July 2, 2008  
ABR-AE-08000047

South Texas Project  
Units 3 and 4  
Docket Nos. 52-012 and 52-013  
Response to Requests for Additional Information

Attached are responses to NRC staff questions included in Request for Additional Information (RAI) letter numbers 32, 36, 39, 40, 49, 50, 54 and 55 related to Combined License Application (COLA) Part 2, Tier 2 Sections 2.4S, 2.5S, 9.1, and 10.4. This submittal includes responses to the following Question numbers:

**Figure 1-** Comparison of TWDB and USGS reported total groundwater withdrawals for Matagorda County from 1985 to 2000.

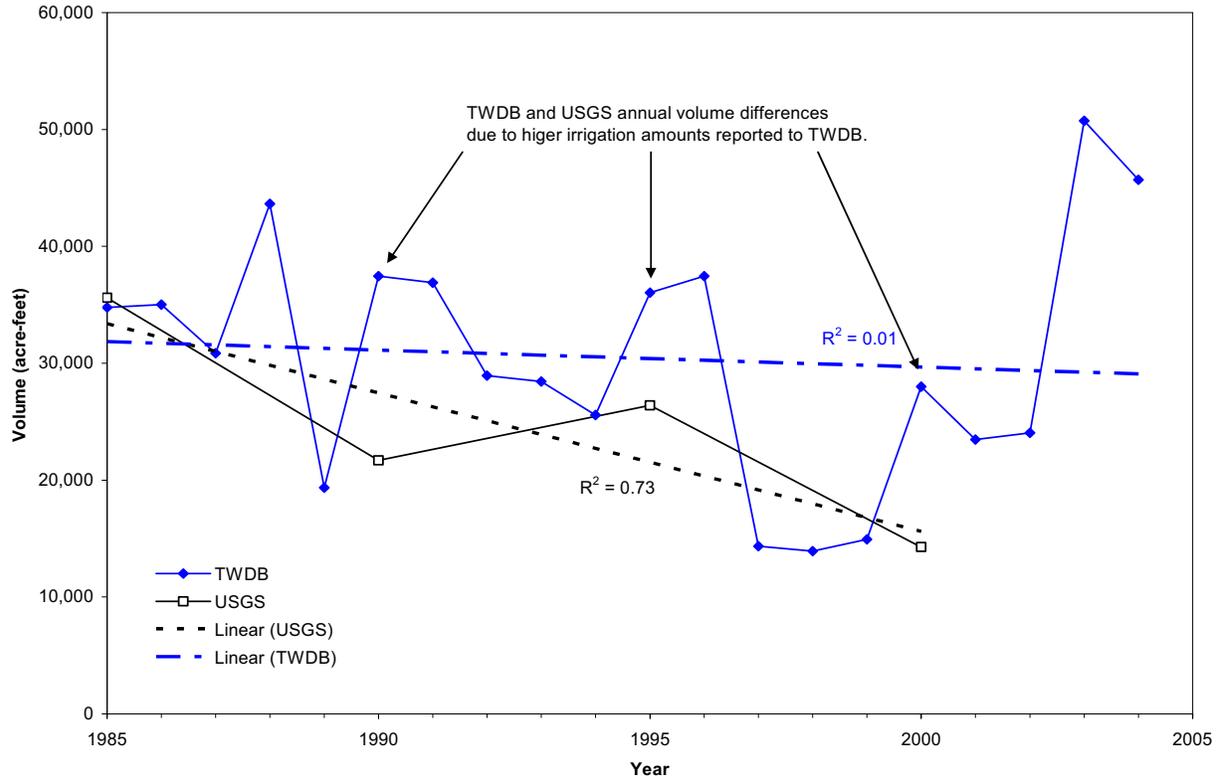
In FSAR Section 2.4S.12.2.1 the applicant states that in 1985 the Texas Water Development Board (TWDB) made projections that groundwater resource use would drop 48% in Matagorda County by 2030. We are about midway through the projection period. Are there data to suggest this is a valid forecast today? Data in Table 2.4S.12-5 suggest groundwater usage is as high now as before. Please clarify and explain the current relevance of the projections.

The USGS data (USGS *Estimated Use of Water in the United States* Internet Weblink) exhibit an overall downward trend from 1985 at about 36,000 AF/Y to 2000 at about 14,000 AF/Y with a fair reliability of correlation of  $R^2 = 0.73$  (Figure 1). Overall, this represents more than a 48 percent decline and as such may validate the 1985 forecast. The TWDB data (TWDB *Historical Water Use Information* Internet Weblink) exhibit more variability, largely due to irrigation, and as a result the TWDB data have no correlation to the generated trend line (Figure 1).

The discrepancy between the USGS dataset and the TWDB dataset for the years 1990, 1995, and 2000 appears to be a result of the large difference in the reported irrigation use totals. The other WUGs appear to exhibit reasonable correlation between the two datasets. This discrepancy suggests that there remains some uncertainty in whether the Texas 1985 forecast continues to be valid. As a result of the variability and tentativeness in the TWDB dataset, the most recent groundwater usage data in Table 2.4S.12-5 should be considered as an interim trend that may be subject to continued variability such as that observed in recent years.

**RAI 02.05.01-2:**

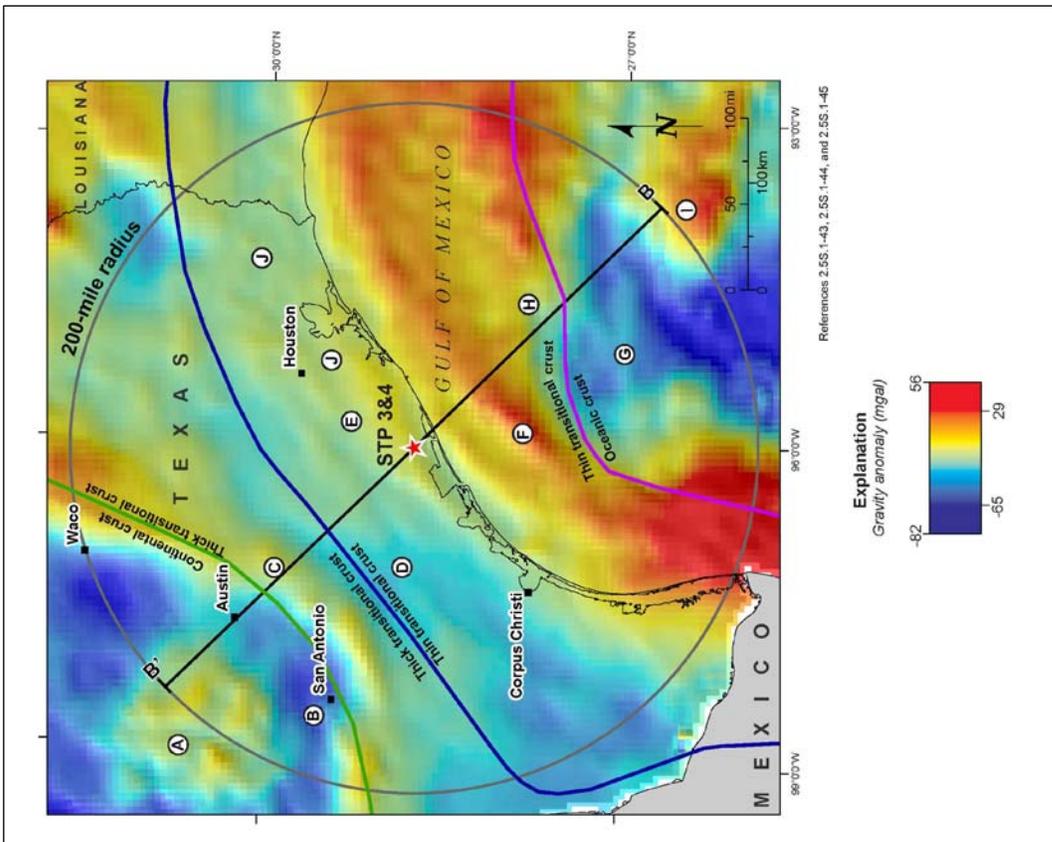
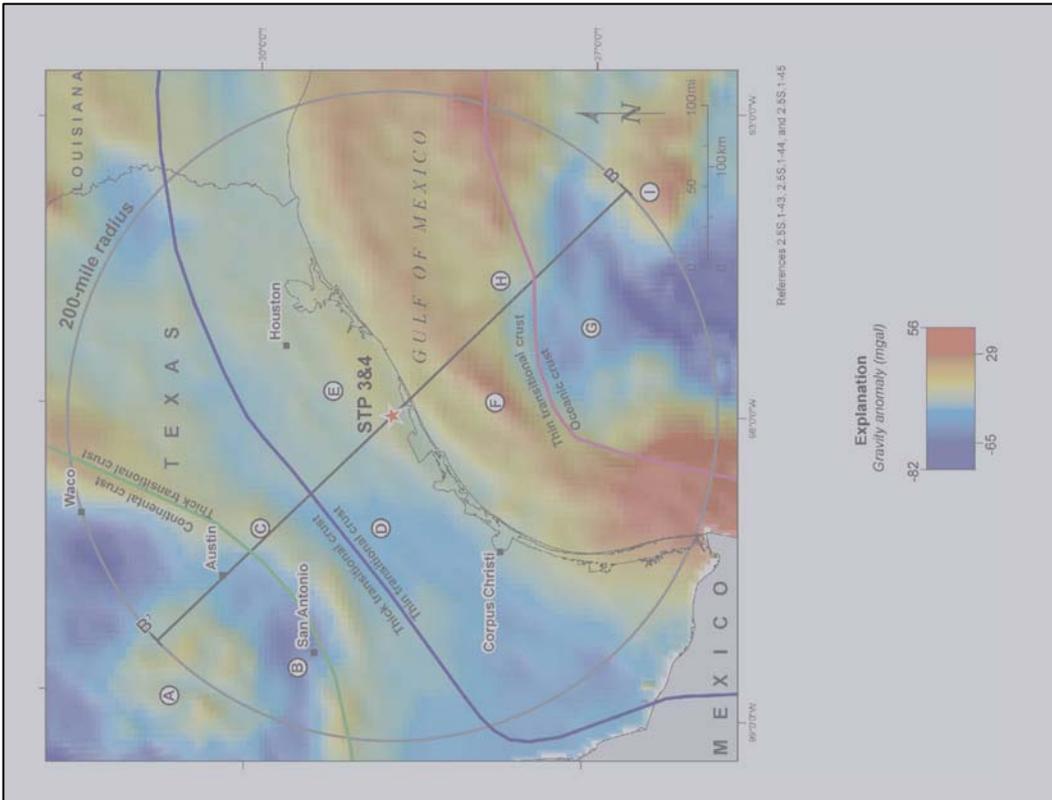
Please label examples of Gravity Feature J on Figure 2.5S.1-15 or Figure 2.5S.1-20 and Gravity Feature E on Figure 2.5S.1-21 and 1-22.

See Figure 2.5S.1-15 with updated labels of Gravity Feature J and Figures 2.5S.1-21 and 2.5S.1-22 with updated labels of Gravity Feature E on the next three pages. Copies of the old figures are attached and grayed out to indicate figures being replaced. The COLA will be revised to replace Figures 2.5S.1-15, 2.5S.1-21, and 2.5S.1.22.

**RAI 02.05.01-17:**

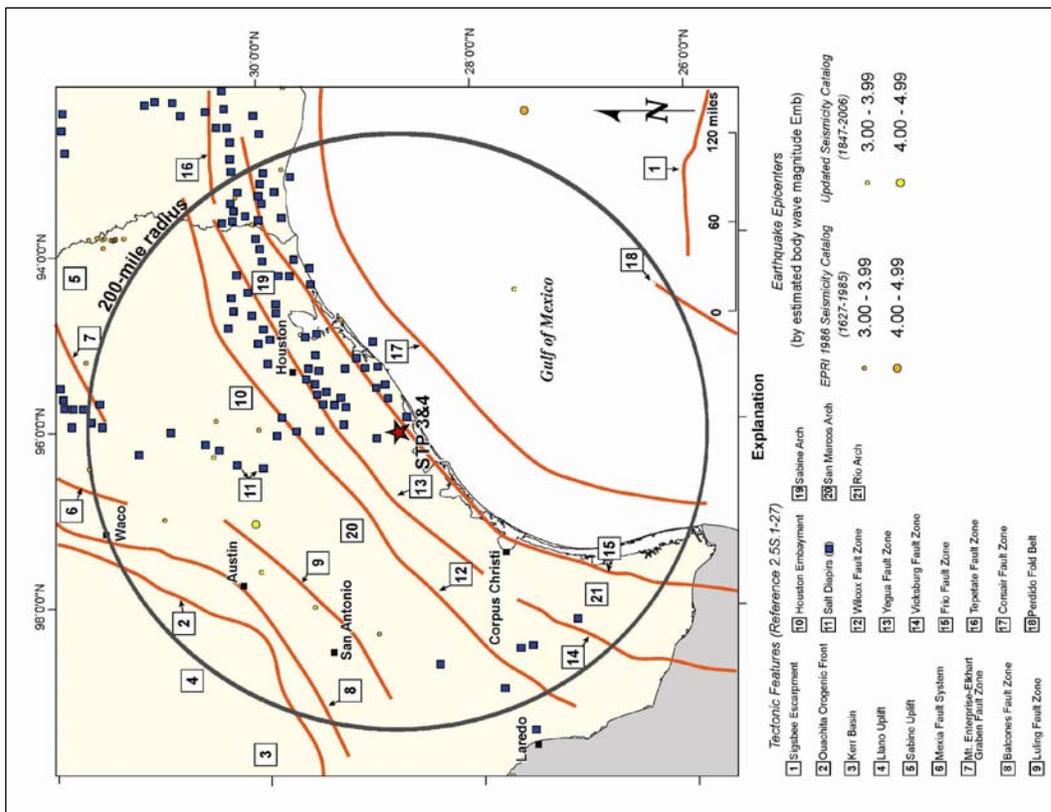
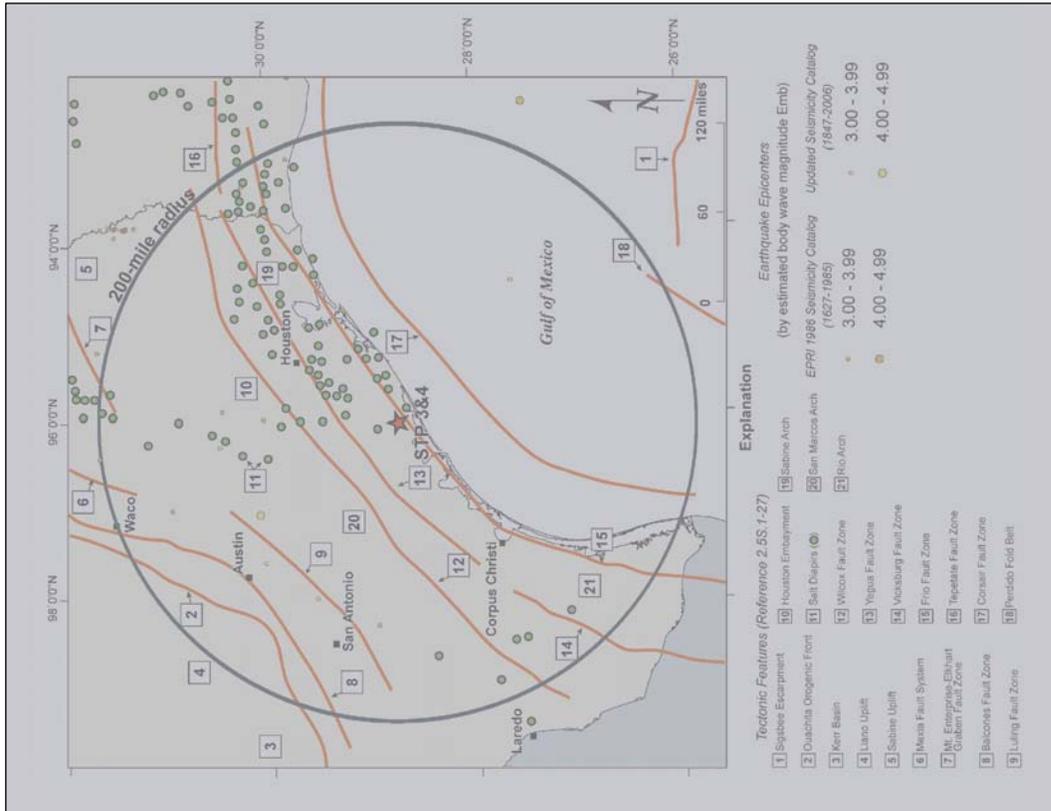
Figure 2.5S.1-17 shows earthquakes and salt diapirs with similar symbols and colors. Please provide a new version of the figure with earthquakes clearly distinguished from the diapirs.

Figure 2.5S.1-17 will be revised with updated symbols as shown on the next page. A copy of the old figure is attached and grayed out to indicate the figure is being revised. The COLA will be revised to replace Figure 2.5S.1-17.

Replace COLA Figure 2.5S.1-17 with the revised version.
